*Southern California Edison Company*

Subject: Docket Nos. 50-361 and 50-362  
San Onofre Nuclear Generating Station  
Units 2 and 3

RESPONSES TO NRC QUESTIONS  
SAN ONOFRE NUCLEAR GENERATING STATION  
UNITS 2 & 3

SEPTEMBER 3, 1980

Figure 121.21-5

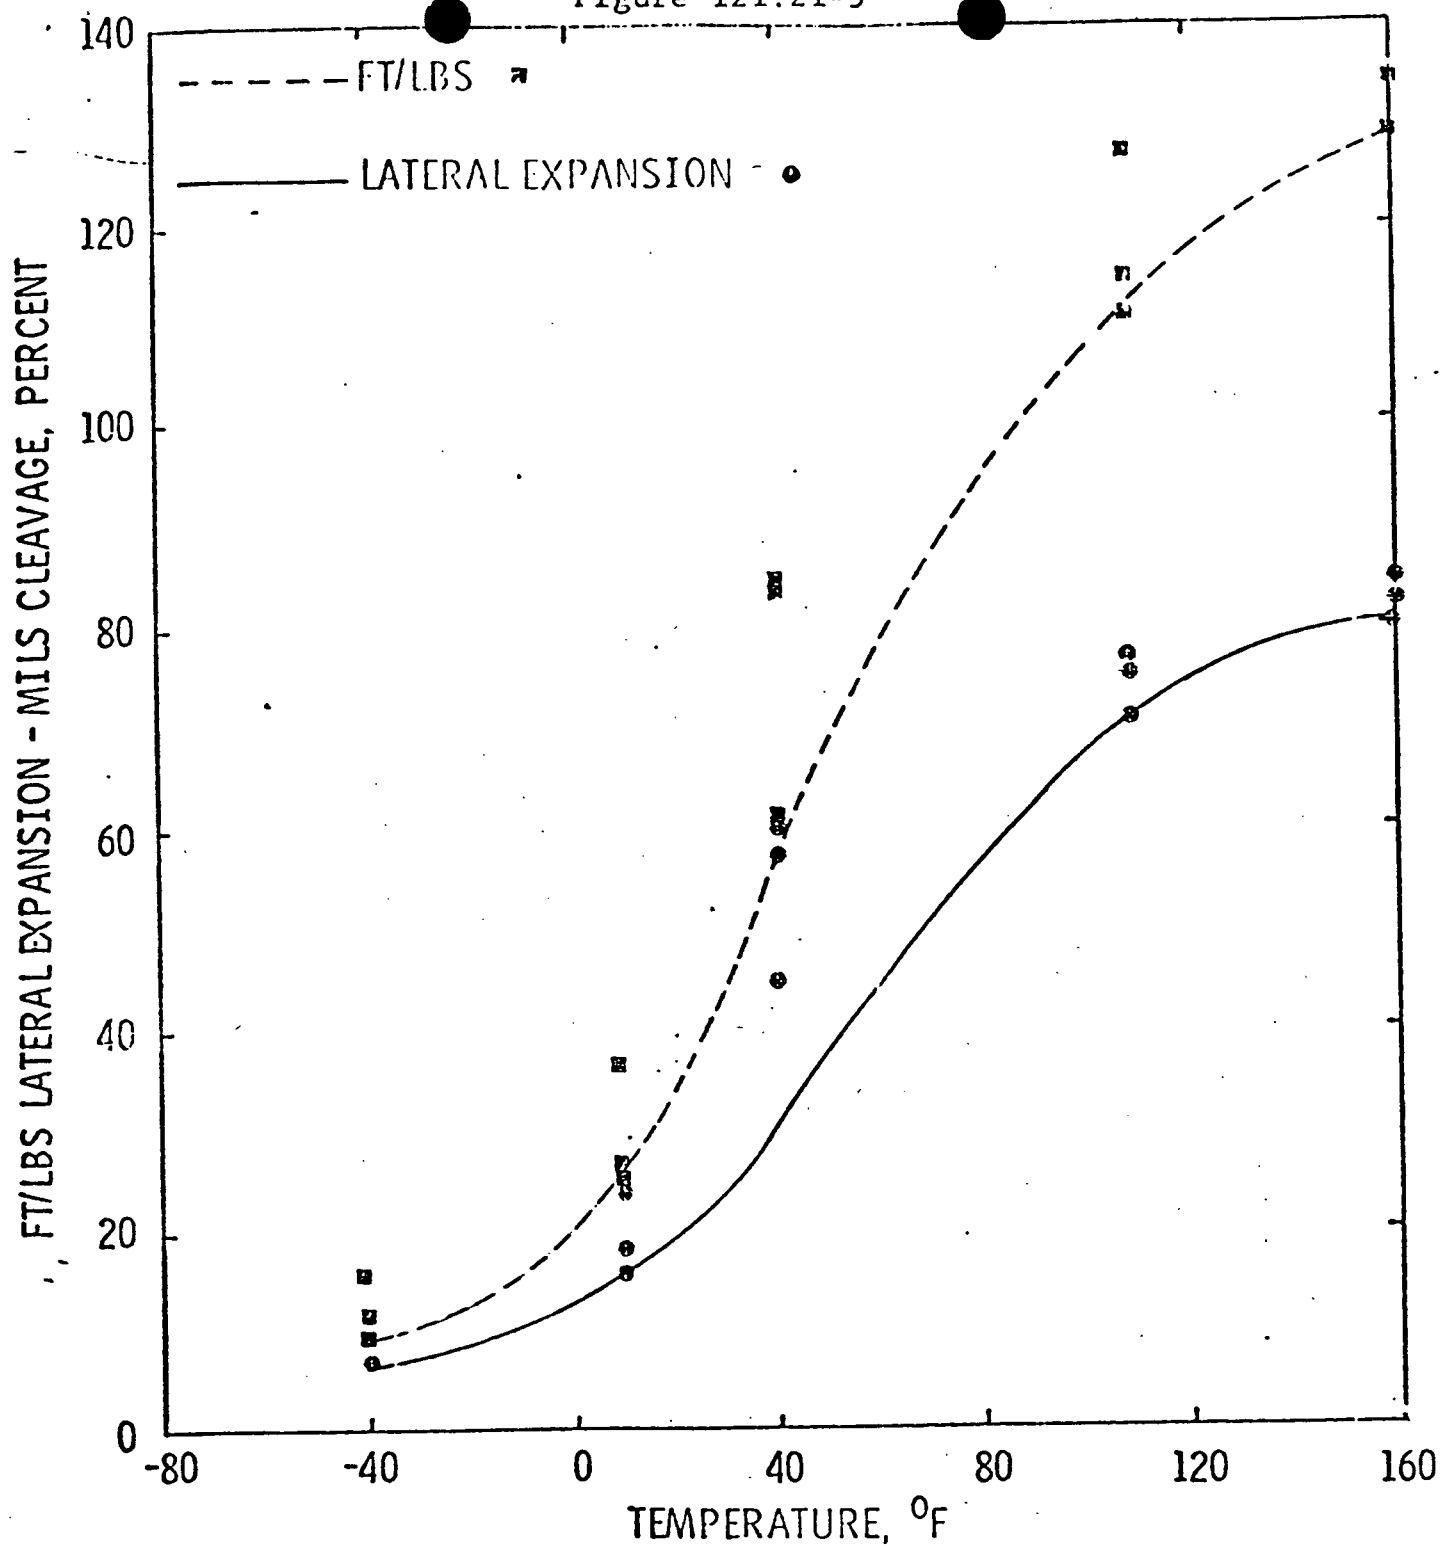
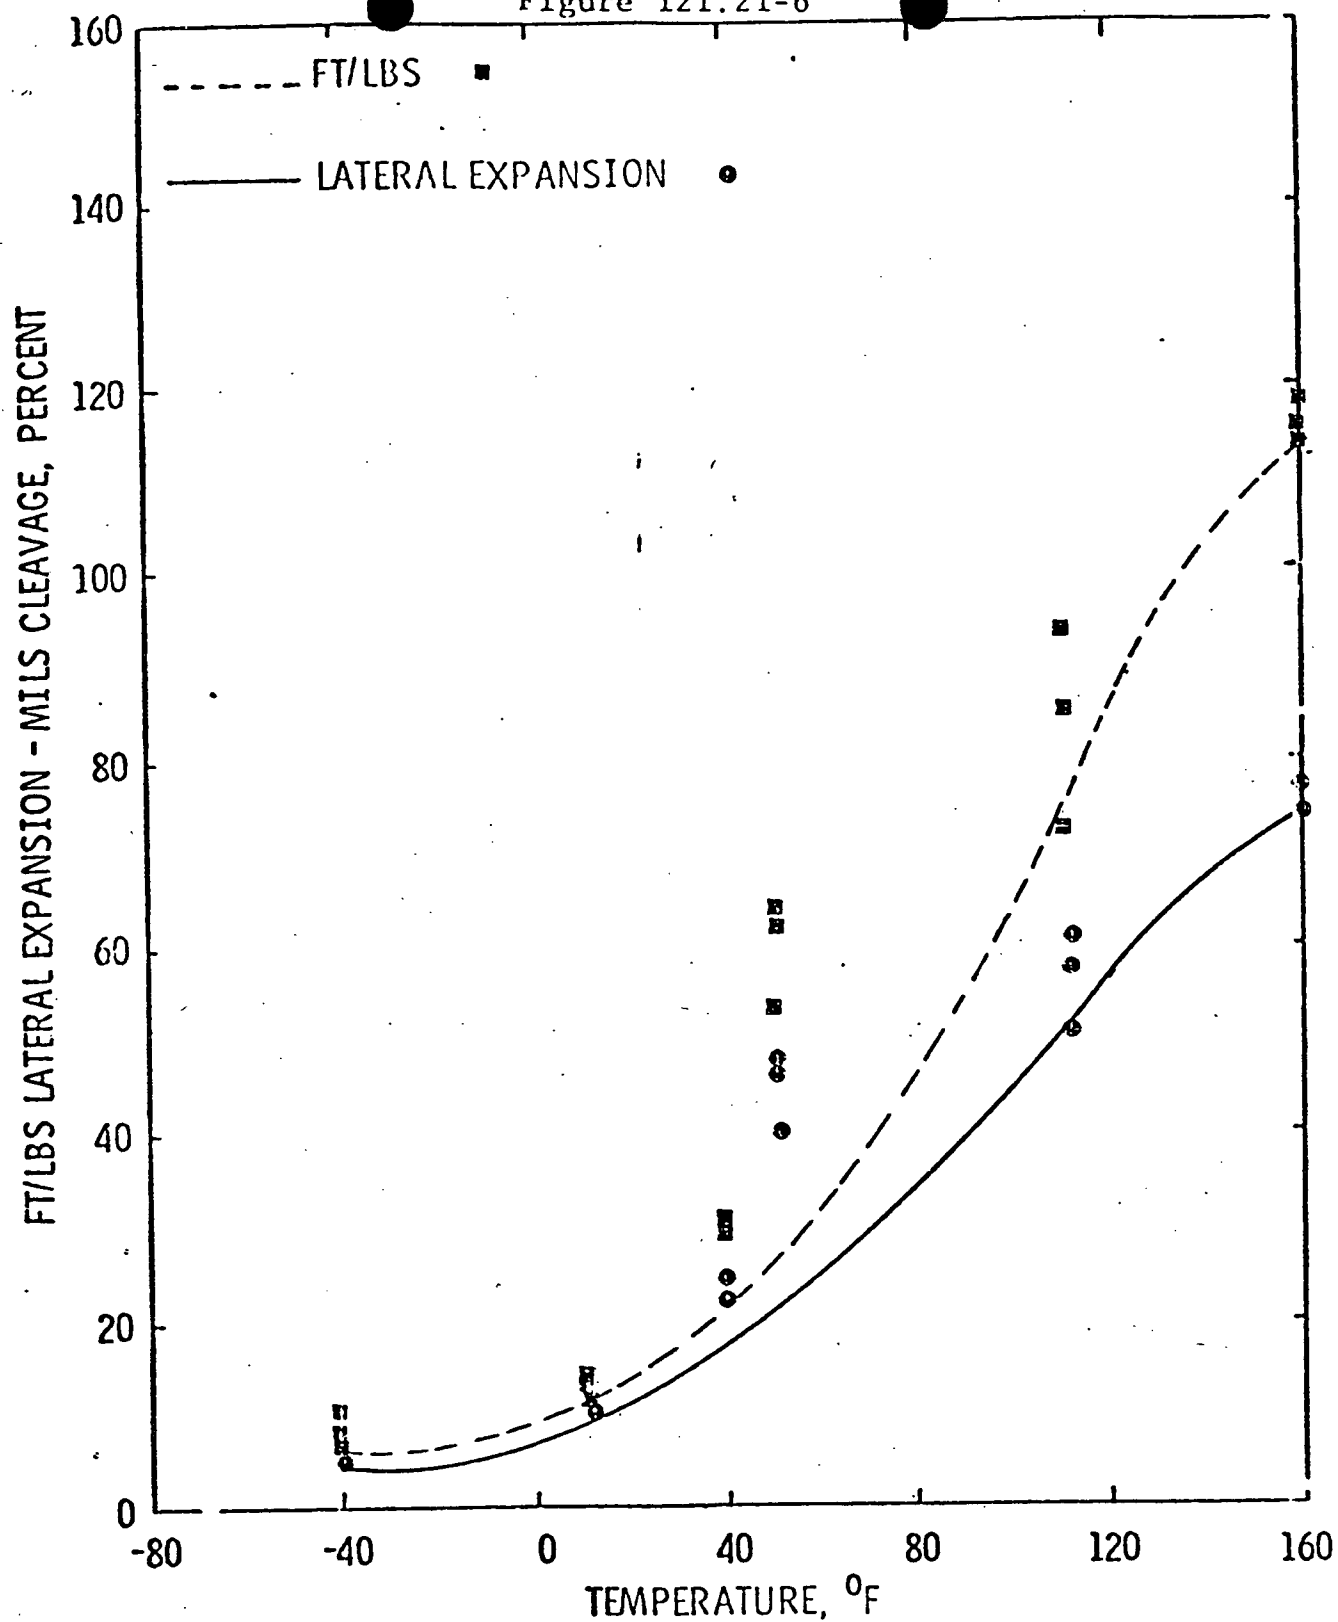
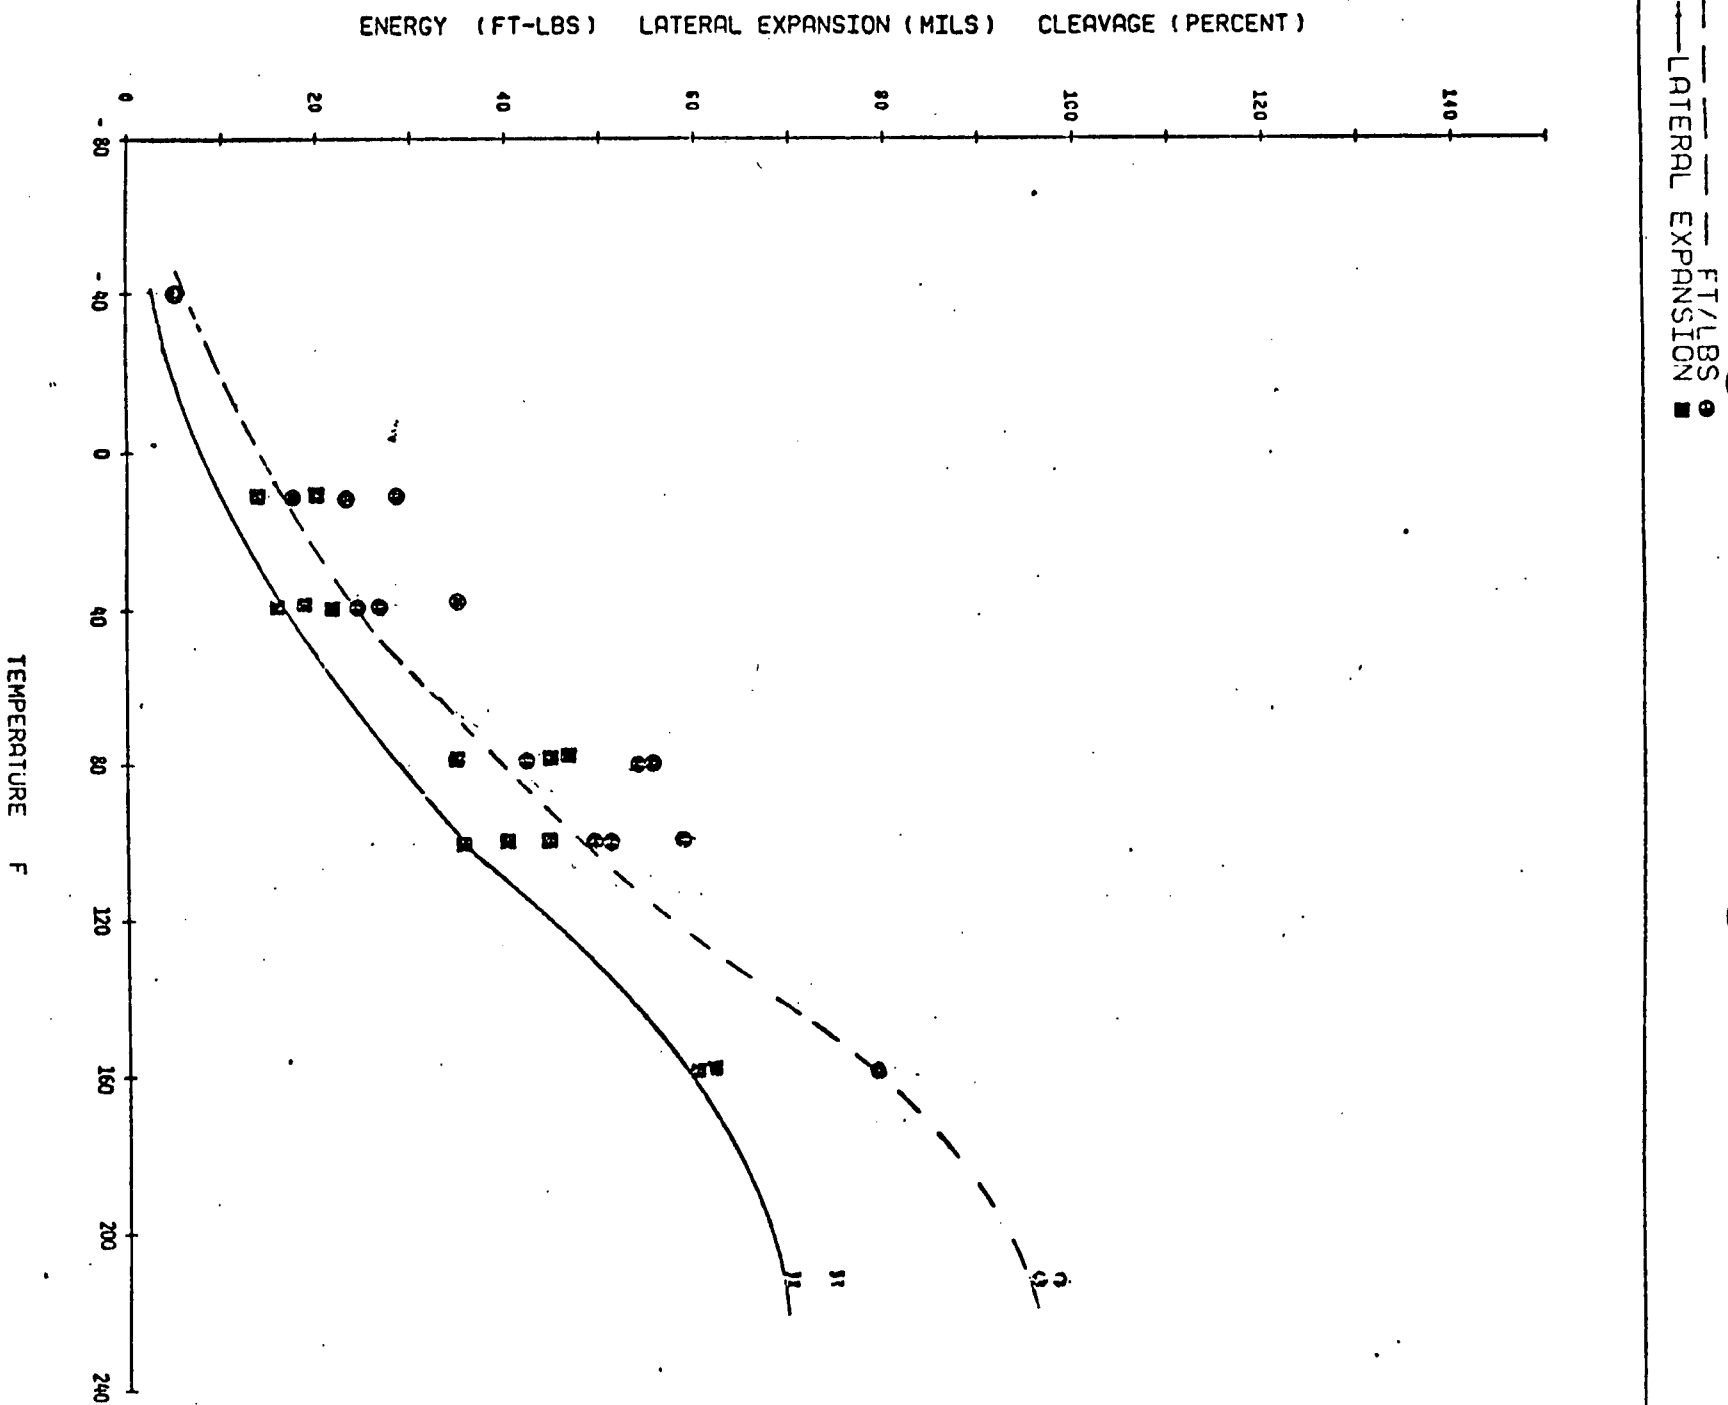
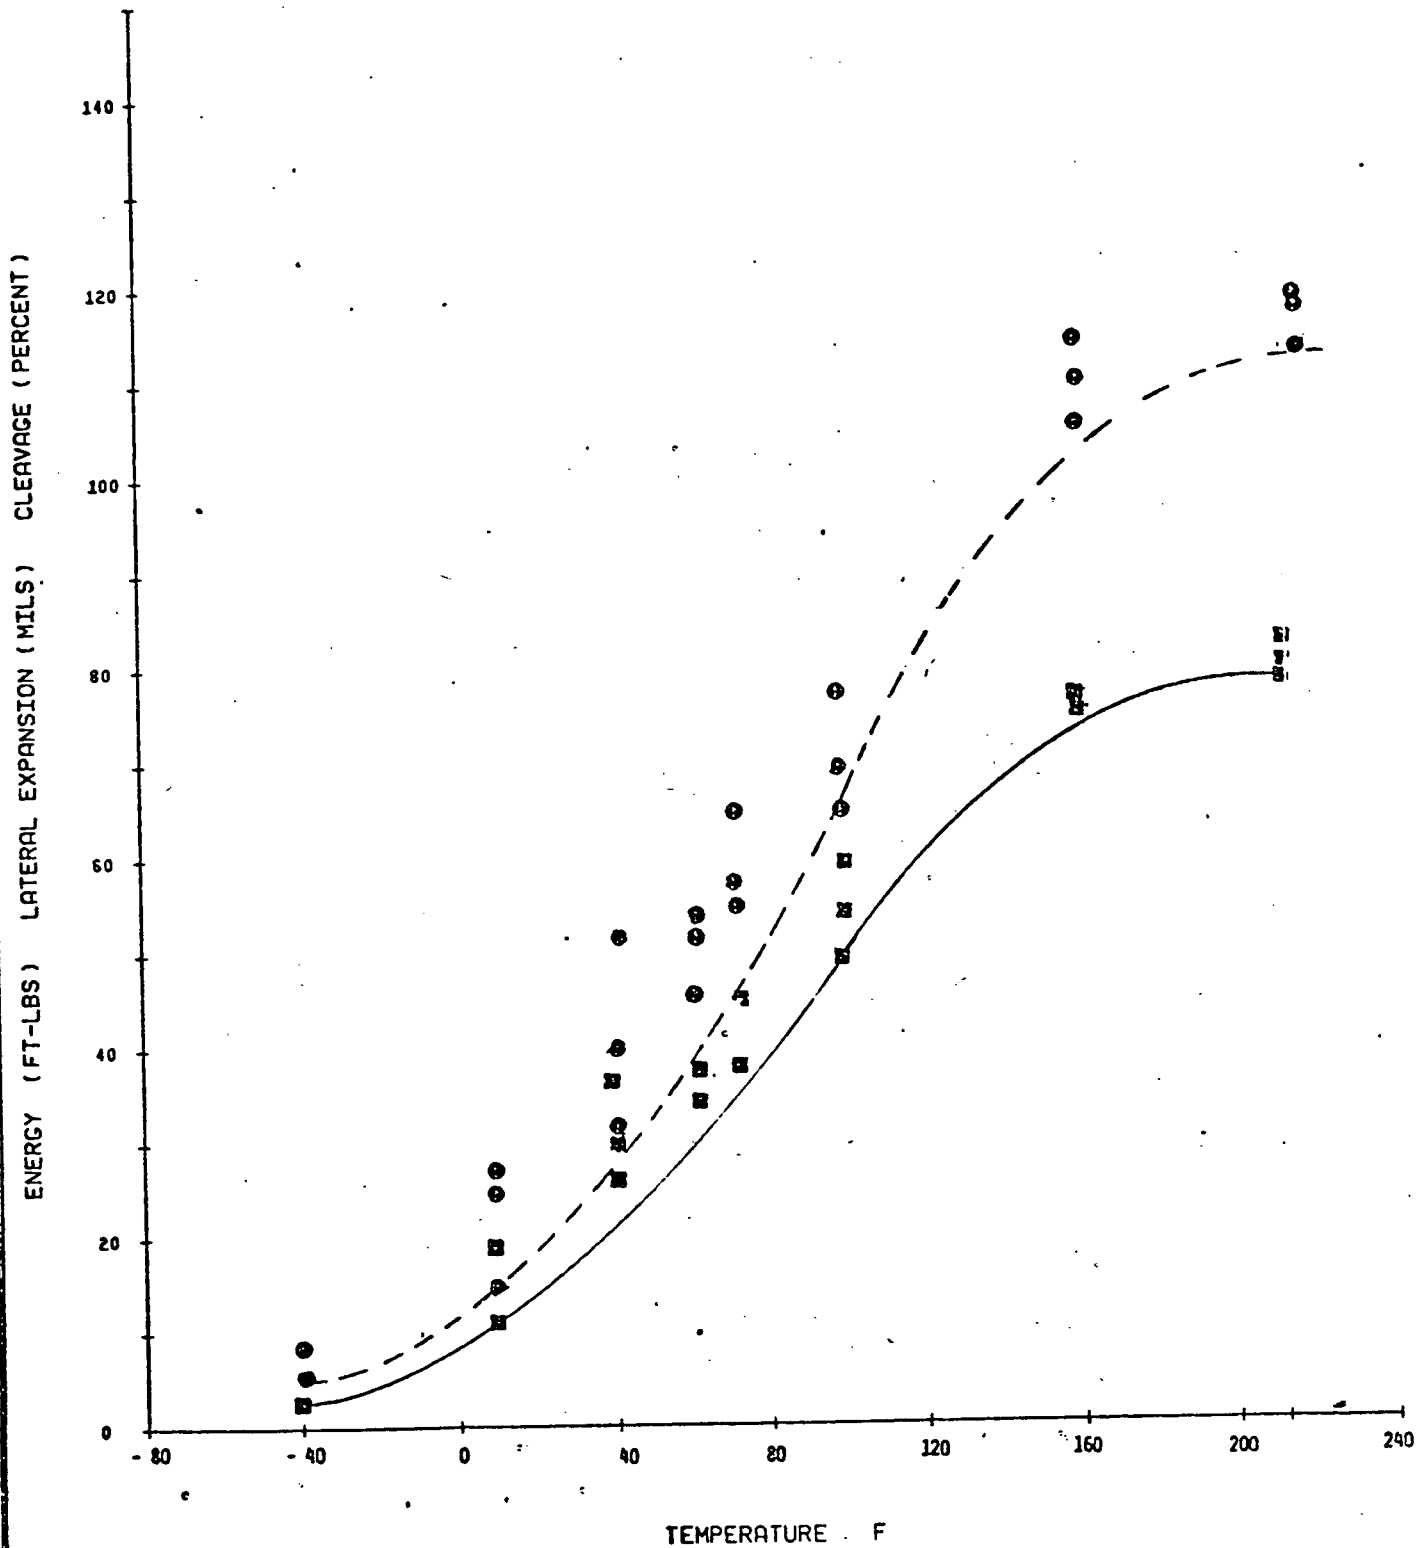
- (1) for the reactor vessel beltline materials, provide full Charpy V-notch curves, including data points, reported in impact energy and lateral expansion, both as a function of temperature;

- (1) Beltline materials Charpy test results for Units 2 and 3 are shown in Figures 121.21-1 through 121.21-12, respectively. The data points have been included. Tables 121.12-1 through 121.21-12 provide the data in tabular form corresponding to the Figures. The revised FSAR figures will be provided by 9/15/80 showing the Charpy test results.
